COUNCIL ASSESSMENT REPORT

Panel Reference	2017SCL020
DA Number	14/306/02
LGA	Bayside Council
Proposed Development	S96(AA) application to modify Development Consent No. 14/306, which is for the demolition of existing structures and erection of a 12 storey hotel building containing 150 rooms over eight levels and four levels of car parking for 60 vehicles (one at grade and three above ground). To convert the plant rooms on the car park levels 2 and 3 to a gym (for hotel guests only) and a staff room respectively.
Street Address	113-121 Baxter Road, Mascot
Applicant	The Baxter International Hotel c/o- Fox Johnston Level 1, 268 A Devonshire Street, Surry Hills NSW 2010
Date of DA lodgement	13 September 2016
Number of Submissions	Nil
Recommendation	Approval
Regional Development Criteria (Schedule 4A of the EP&A Act)	Section 96AA Application to modify a consent determined by the NSW Land and Environment Court, pursuant to Clause 21 of State Environmental Planning Policy (State and Regional Development) 2011

List all documents submitted with this report for the Panel's consideration	<ul style="list-style-type: none"> • Architectural plans prepared by Fox Johnston
Report prepared by	Kate

Figure 3: Carpark Level 2 floor plan extract

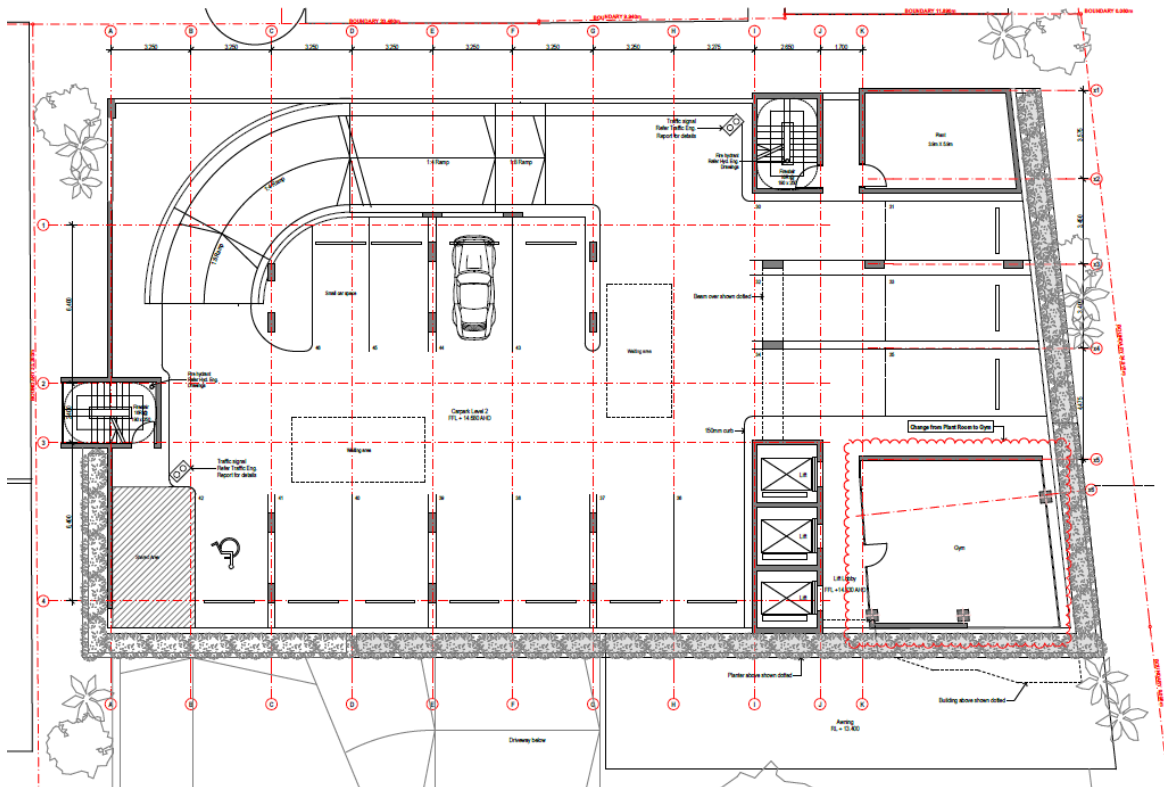
The applicant seeks to convert the existing plant rooms on the car park levels 2 and 3 to use these as a gym room for hotel guests and a staff room respectively. The applicant has advised that:

“Car park levels 2 and 3 have plant rooms approved in the north eastern and south eastern corners to which the northern plan rooms are adequate for the containment of plan and equipment required. The inclusion of these rooms within the overall gross floor area represents an increase from 4636.55m² (approved) to 4734.42m² (proposed) is 97.87m². This equates to a new FSR of 3.19:1 from the approved 3.13:1. In respect to operations and occupancy of these room changes, the gym room will only be used by hotel guests and will not operate commercially. Being for the use of guests only, there will be no intensification on parking requirements”.

The approved proposal did not accommodate a gym (for hotel guests only) or a staff room, as such the proposed modification will provide greater amenities to the hotel guests and staff. As there is no change to the building footprint or building façade, no objection is raised to this modification.

Figure 4: Carpark Level 3 floor plan extract

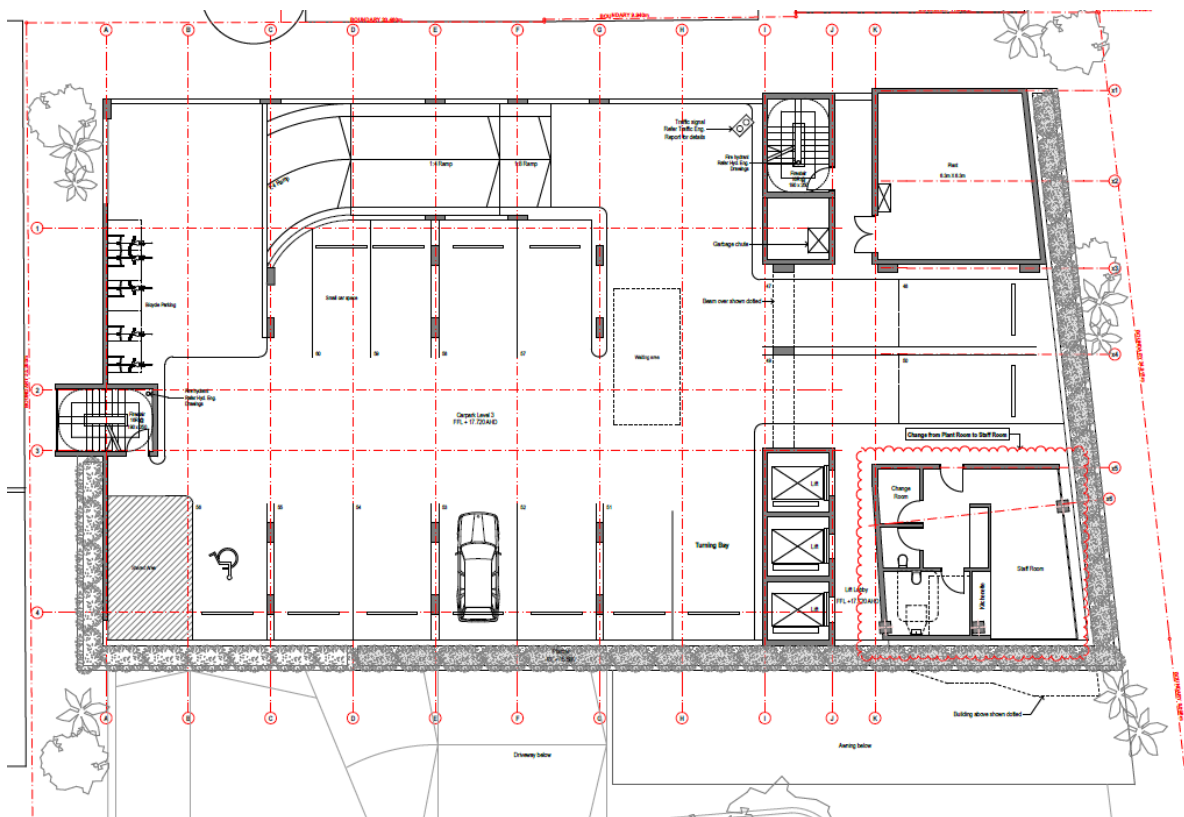
- Conversion of approved plant room to staff room.

Project	The Baxter International Hotel	Job No.	1304	Dwg No.	Rev.
Scale	1:100 @ A2	Date	October 2014	DA 1.04 D	
Title	Carpark Level 3	Drawn/Checked	BP/CJ

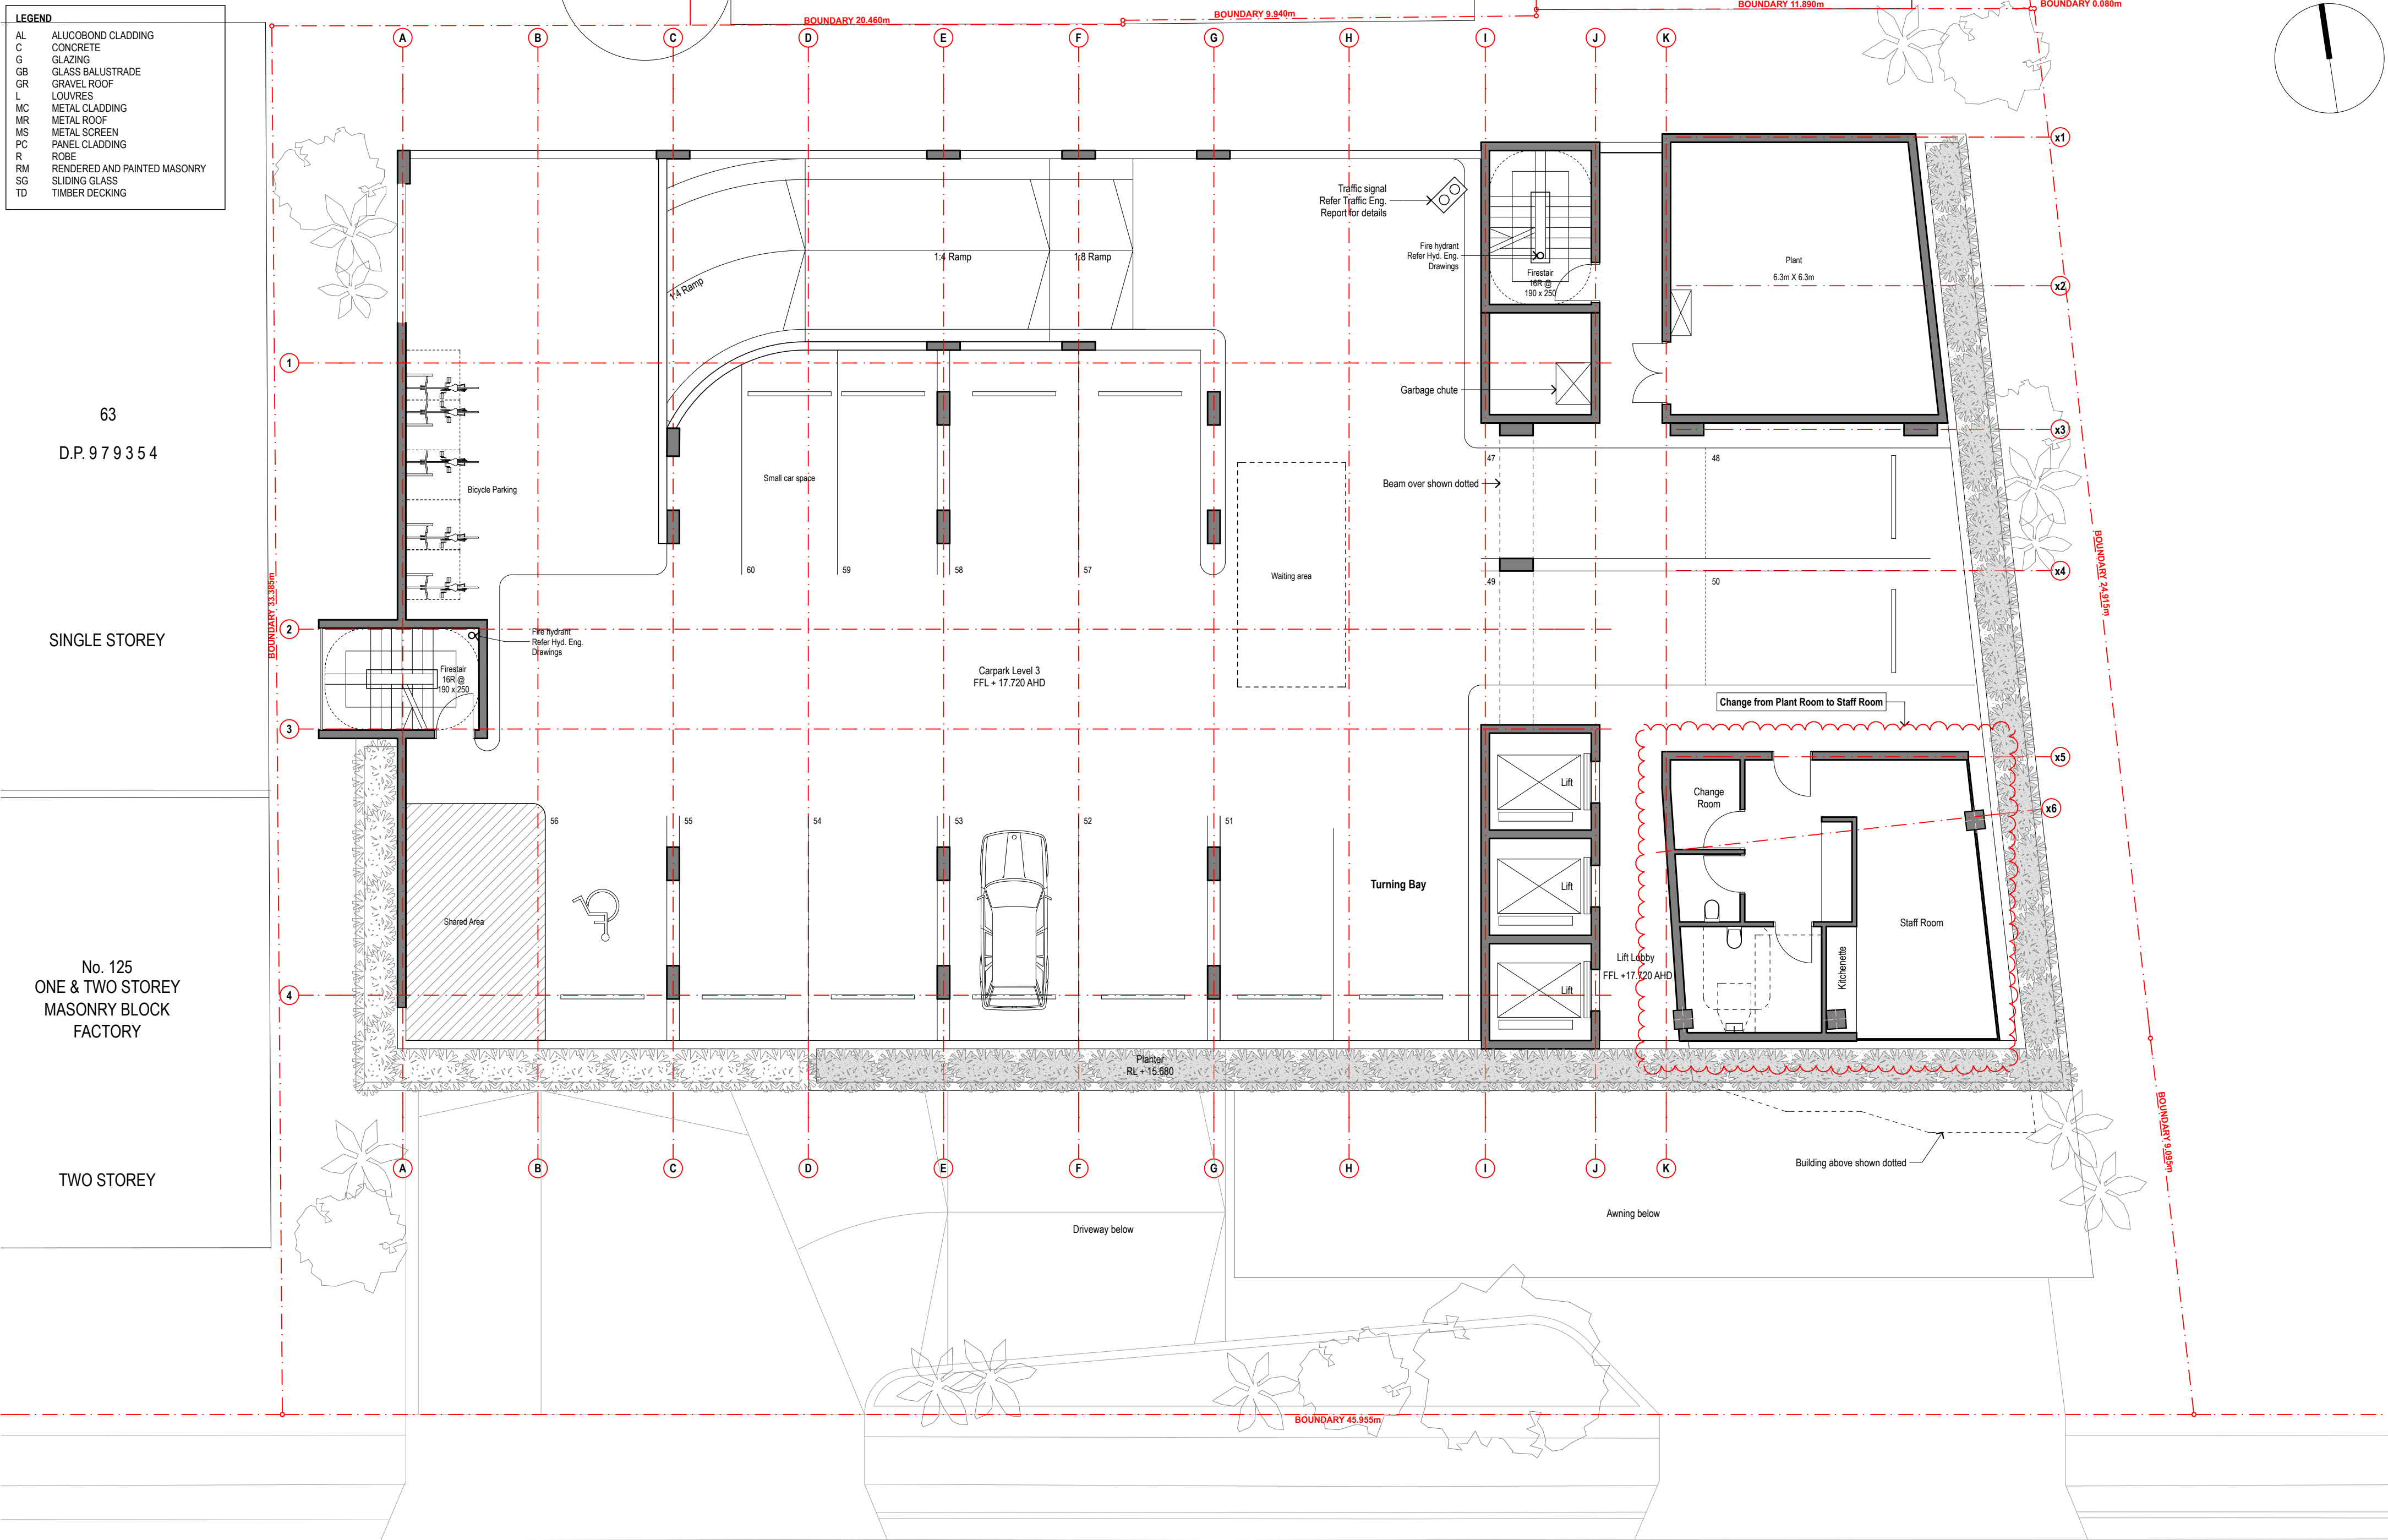
Rev	Description	Drawn/Checked	Date
A	Revised DA	SJ/CJ	20/03/15
B	Revised DA	SJ/CJ	23/03/15
C	Section 96 - Change of Plant to Staff Room	SJ/CJ	07/09/16
